## EXECUTIVE SUMMARY

Good morning to you all. I am Mary Bourke a Trustee of the Henmar Trust.

My submission, further submission, brief of evidence and further information have all been circulated for sometime and I shall take them as read, focusing on the outstanding issues raised and the relief sought by Henmar Trust that have been rejected by Council.

Figure 2: C10 Master Plan – Water Supply Strategy

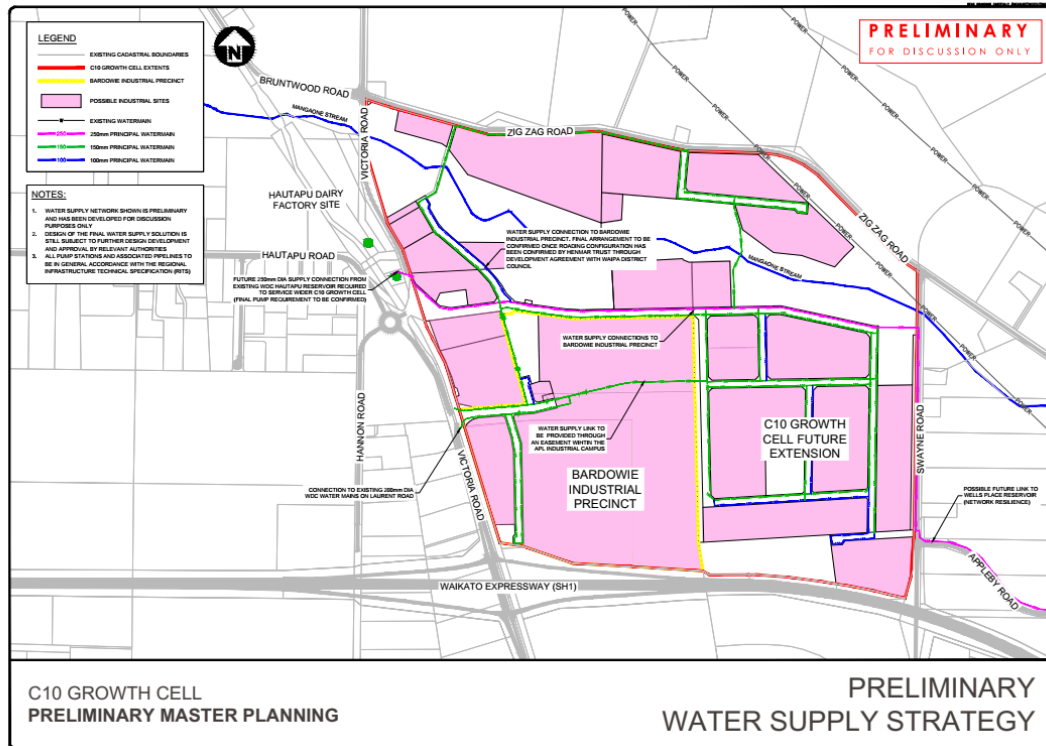
It is essential that Council’s water and wastewater are extended to a location where the Henmar Trust land north of the Mangaone Stream can connect to in the future, that is either to their boundary or to Zig Zag Road. This also applies to public utilities such as power, gas and fibre. Stopping the services within the Mangaone Precinct, leaves that access to these services in the control of developers, not Council, severely comprising the future development of the C10 Growth Cell. This was recognised in the C10 Masterplan (prepared by an Engineering Expert engaged by Council) which clearly shows these services extending to the Henmar Trust boundary north of the Mangaone Stream.

As outlined in Figure 2 below, the C10 Masterplan clearly shows the water supply extending to Zig Zag Road, and along to the Henmar Trust boundary.

Figure 3: C10 Master Plan – Wastewater Strategy

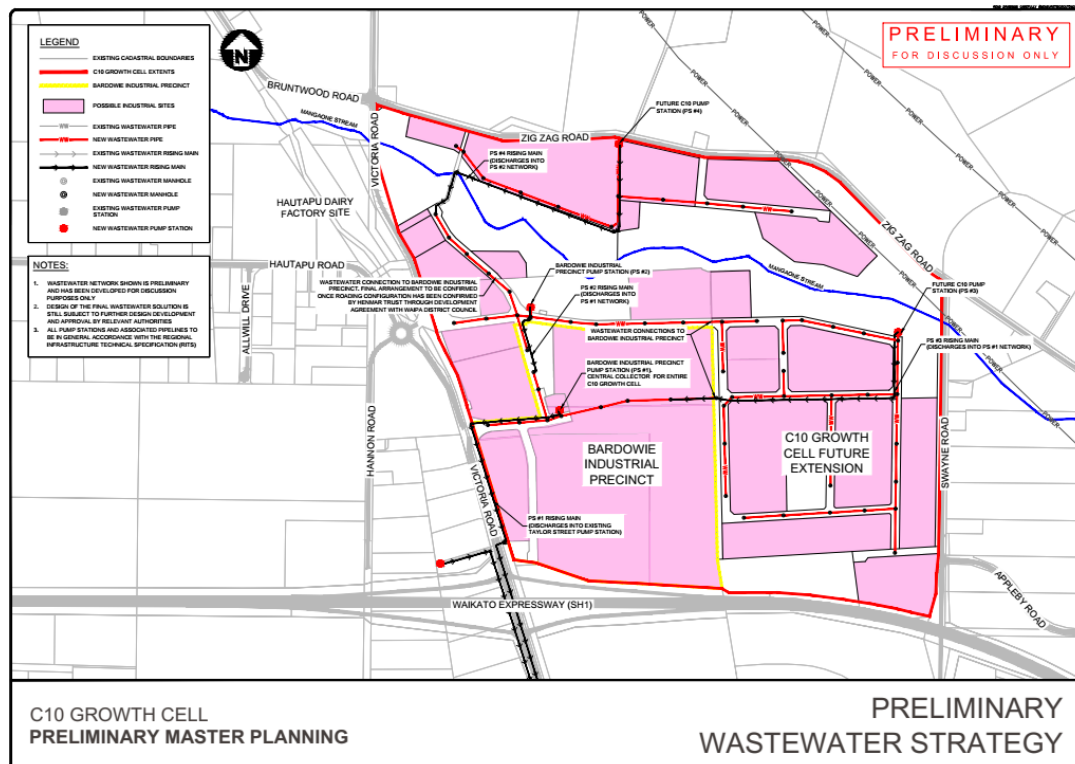
Figure 3 below, from the C10 Masterplan clearly shows the wastewater system extending through the proposed Mangaone Precinct to the Henmar Trust boundary.

If these services stop within the Mangaone Precinct as proposed by PC14, access to Council and public services to the north of the Mangaone Stream will be controlled by Fonterra. Henmar Trust will never have access to these services, leaving Bardowie Investments Limited and Fonterra with the control over as and how the C10 Growth Cell will develop. This is the role of Council, not developers.

Figure 4: C10 Master Plan – Utility Services Strategy

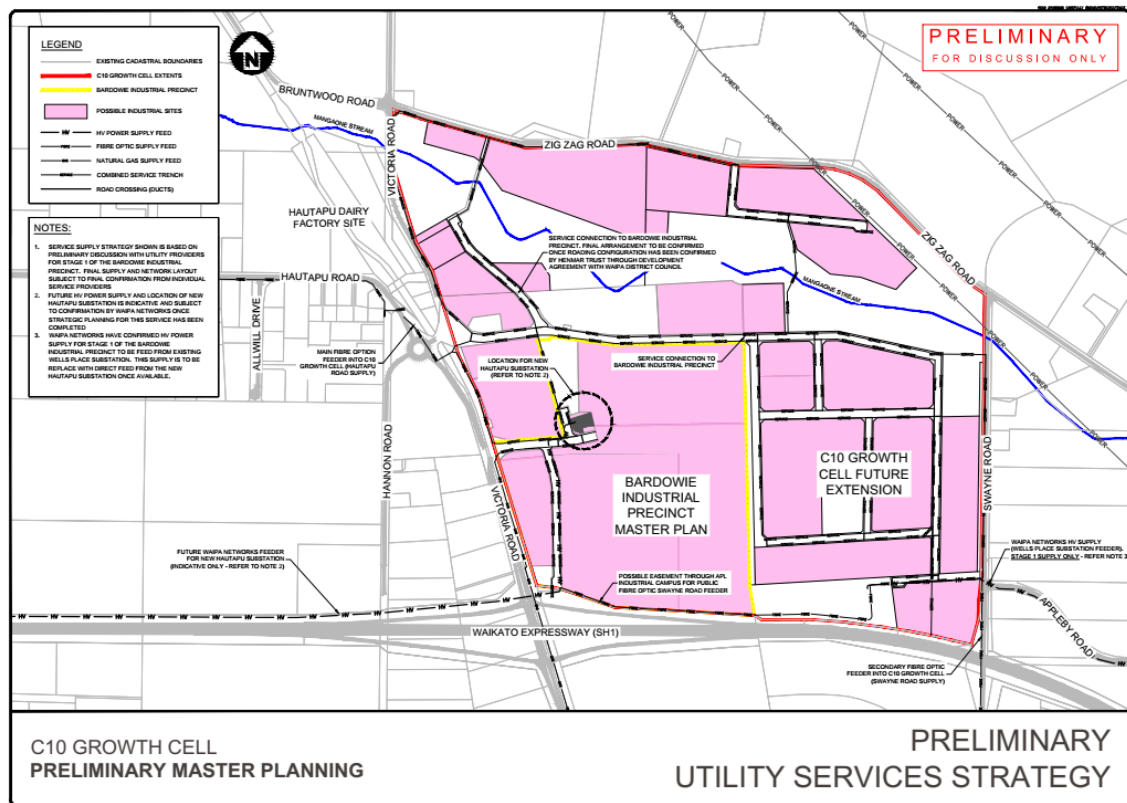
Figure 4 below, the C10 Materplan Utility Services Strategy clearly shows the utility services going to Zig Zag Road so that Henmar Trust can connect.

Figure 6: C10 Preliminary Transport Network

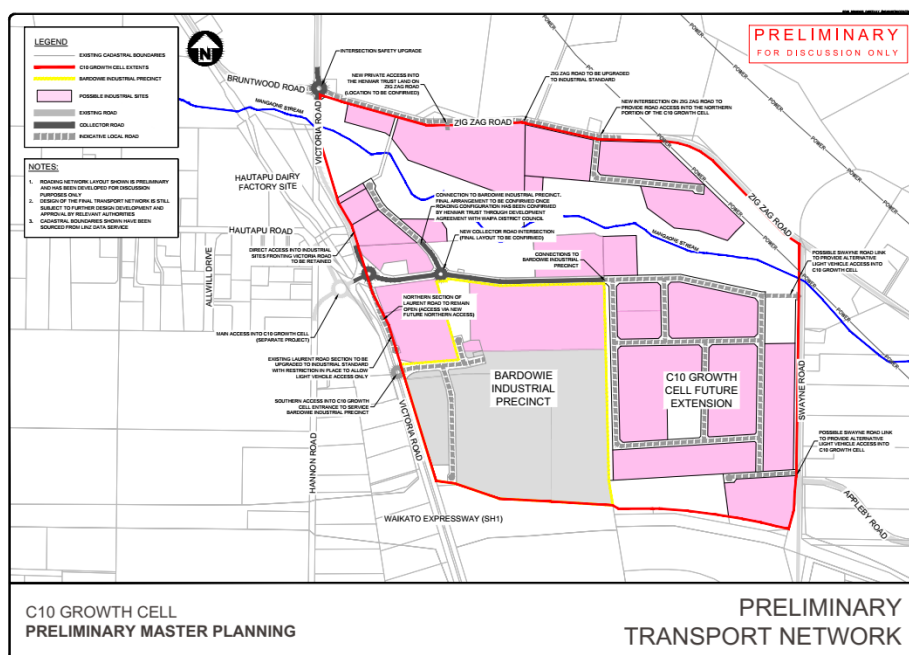
It is a very real probability that the proposed east-west collector road and the Zig Zag Road access may not be built for many years, with the Swayne Road access being built to provide an Industrial access to the Precinct and then use the existing local roading network, as APL have, with making no contribution to upgrading the existing local roading network.

The latest C10 Master Plan we were emailed showed the Mangaone Precinct having a connection into the Kiwifruit Block gaining access to the Kiwifruit Block’s existing vehicle entrance on Swayne Road. Please see figure below.

**Figure 8: Ms Jacks Diagram**

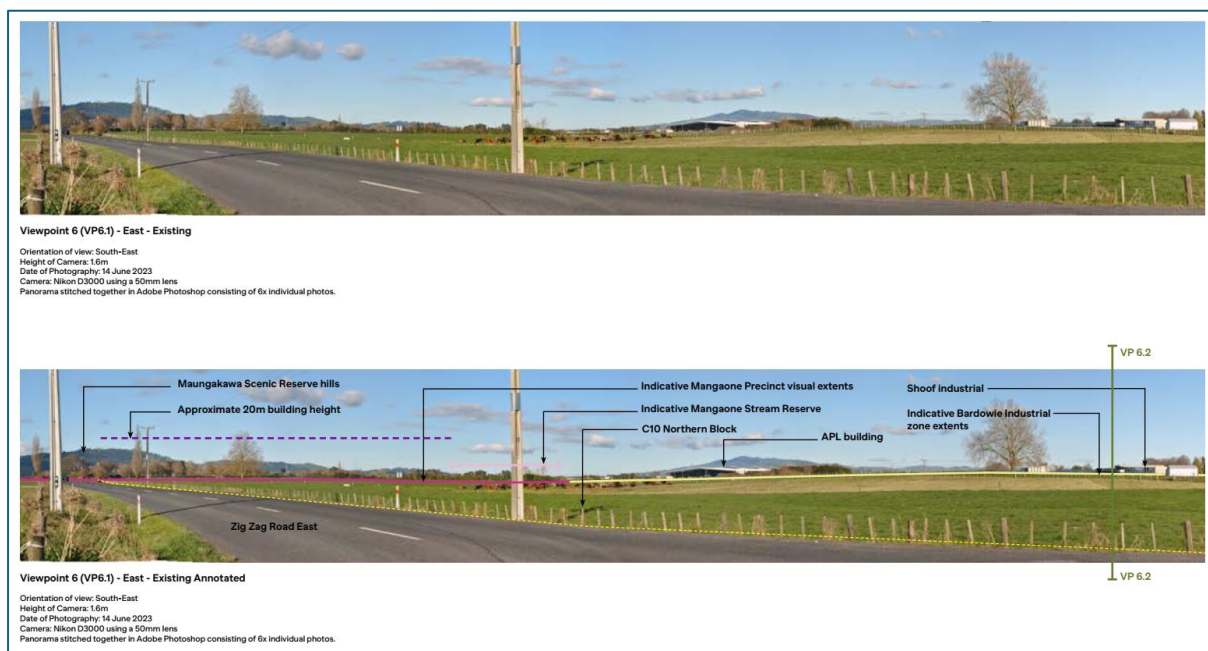
The impact of the proposed plan change as viewed from the Henmar Trust entrance at 35 Zig Zag Road is illustrated in the Diagram below (Figure 8) prepared by Ms Jacks, Fonterra Landscape Expert. This is the entrance to the Henmar Trust land that is located on the northern side of Zig Zag Road and outside the C10 Growth Cell. As illustrated below the impact on the amenity and wellbeing of this rural property is significant.

**Figure 9: Ms Jacks Diagram showing 20m high buildings and 2m high hedge**

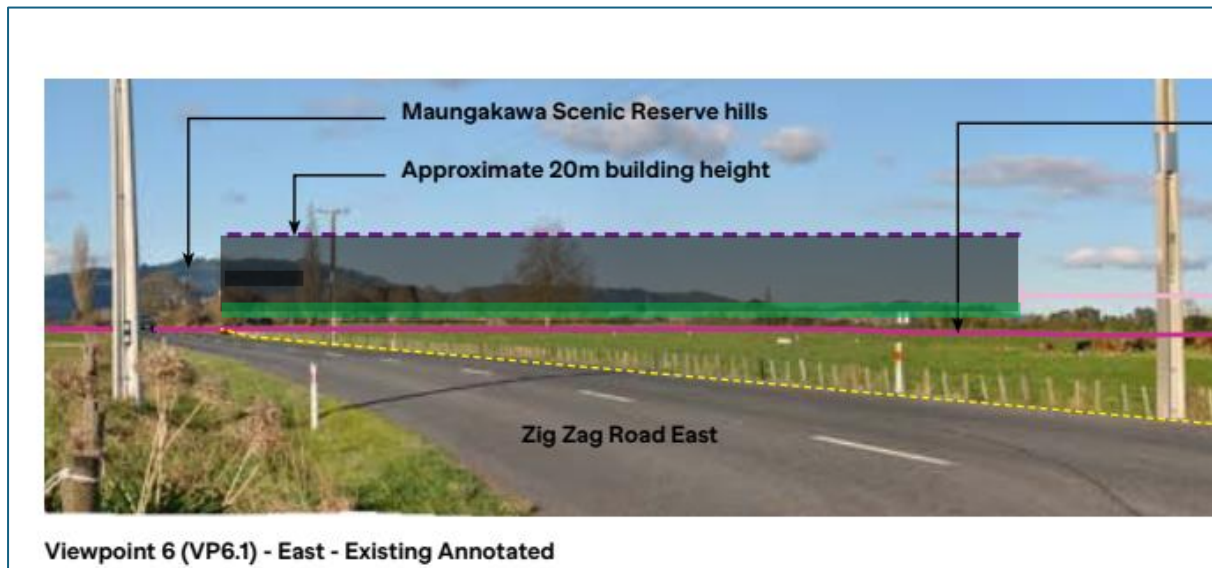
The proposed Plan Change provides for Industrial buildings to be 20 metres high and this has been highlighted in black below. You will see a green highlight at the bottom of the proposed buildings, this is the proposed 2 metre high hedge that Ms Jacks has advised will soften the visual impact on the Henmar Trust land, including the land that is located outside the C10 Growth Cell and is zoned Rural.

Although I'm not an expert, it is clear to me that the proposed 2 metre hedge does little, if anything, to soften the amenity effects.

It is requested that the road setback be 15 metres. Any outdoor storage of materials in this space or other unwanted activities can easily be prevented through the performance standards of the District Plan.

It is requested that there is a minimum setback from the Henmar Trust boundary with the Mangaone Precinct of 15 metres.

**Figure 11: Ms Jacks Diagram showing proposed 12m high buildings and 2m high hedge**

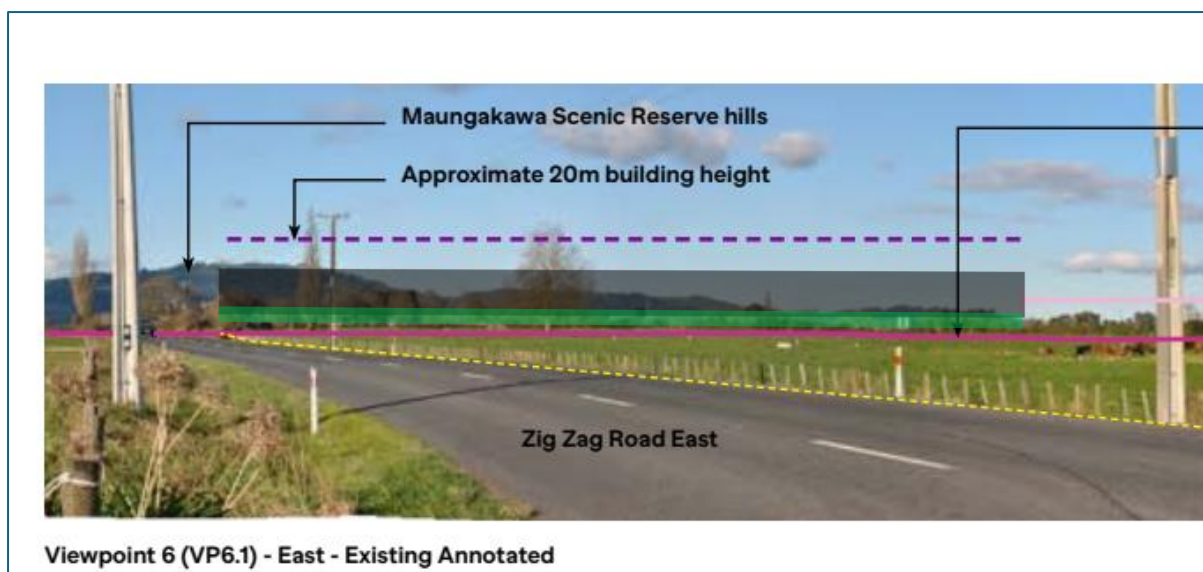
Additionally, as illustrated in Figures 8, 9, and 11 the proposed 2 metre high hedge has little impact on screening the visual impact of the proposed rezoning.

It is requested that the height be reduced to 12 metres, which is more in line with the ridgeline of the Mangakawa Scenic Ridgeline Hills. Please refer to Figure 10 below.

It is requested that trees be required to be planted along this boundary to mitigate the visual impact on the Henmar Trust land located to the north of Zig Zag Road and within the Rural Zone.

Figure 12: Waipa District Plan – Hautapu Industrial Precinct Structure Plan

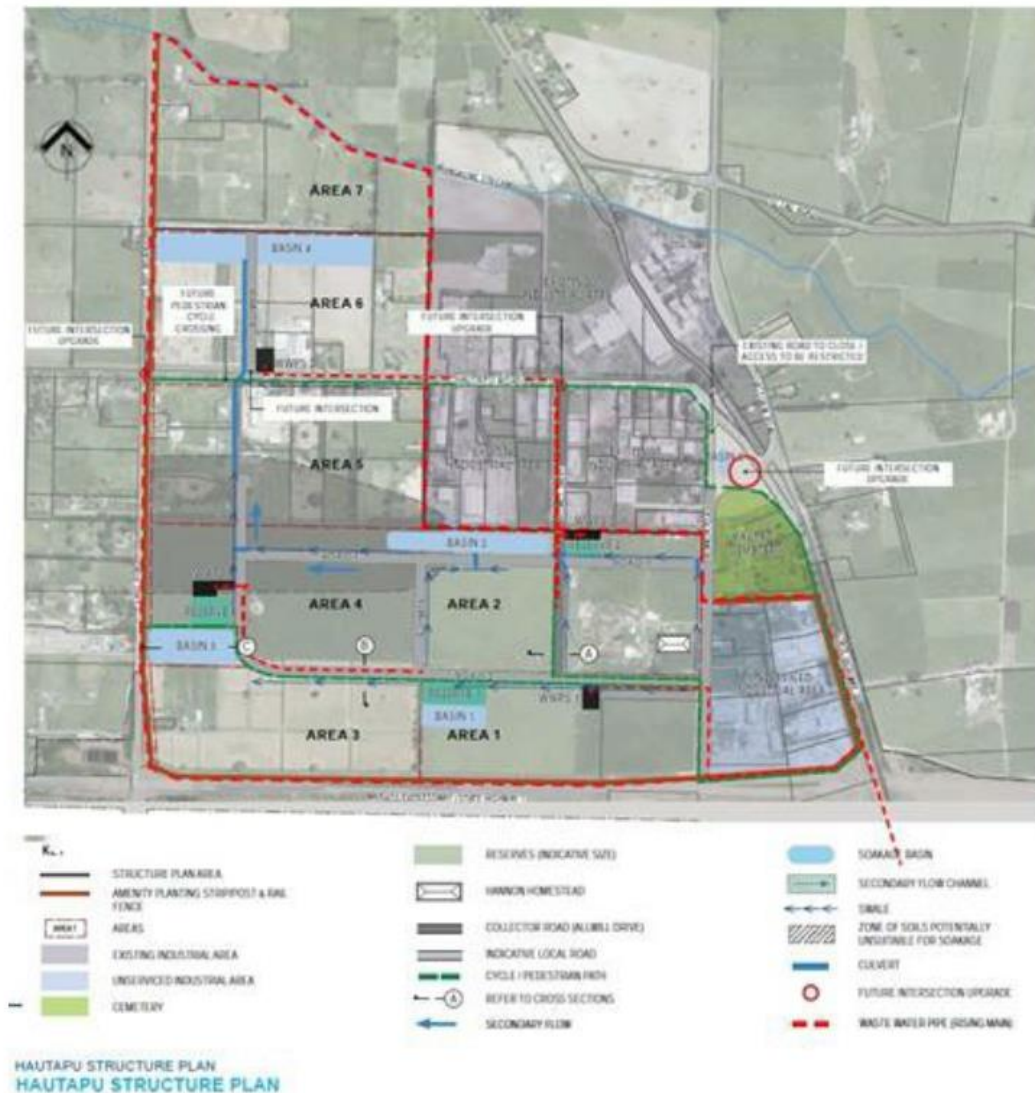
Council recently approved PC17 which created the live zoning of Industrial land (Area 6) and rezoned land Deferred Industrial (Area 7) within the Hautapu Industrial Precinct, approximately 150 metres to the west of C10. See below.

For Council staff to state that the boundary between Areas 6 and 7 is not a rural/interface is misleading. Area 6 is zoned Industrial and Area 7 is zoned Deferred Industrial. This means that the underlying zoning of Area 7 is Rural, and the Rural Zone rules apply to Area 7.

The layout of Area 6 was substantially altered to provide connectivity to Area 7 and the stormwater ponds were relocated to mitigate some of the Industrial effects on the land within the Deferred Industrial Zone (area 7). Additionally, a 15-metre setback is required by Rule 7.4.2.2 of the District Plan (highlight yellow below).
